# Technical Bulletin

**No:** TDL-0143-B  
Page 1 of 1  
ITDL-0045-B

**Product**  
Laundry

**Issue** Melted Motor Pulley.

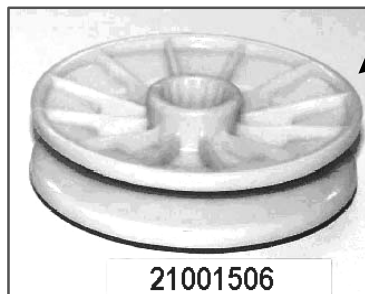
**Action** As an alternative to removing and replacing the entire motor assembly from the washer, a new pulley kit, part number 12002815, has been created. This will allow you to replace only the pulley on the motor and save you time in the home and be less expensive for the consumer. The pulley kit is comprised of two pulleys for the two different motors used on the washers.

**NOTE: It is important to replace the correct pulley onto the motor**, by matching the pulley on the motor with the matching pulley in the package. The kit comes with simple instructions on how to remove the pulley from the motor shaft.

Part No. 21001516, motors built **before 8/18/03** requires old pulley part number 21001506.

Part No. 21001950, motors built **after 8/18/03** requires new pulley part number 22004297.
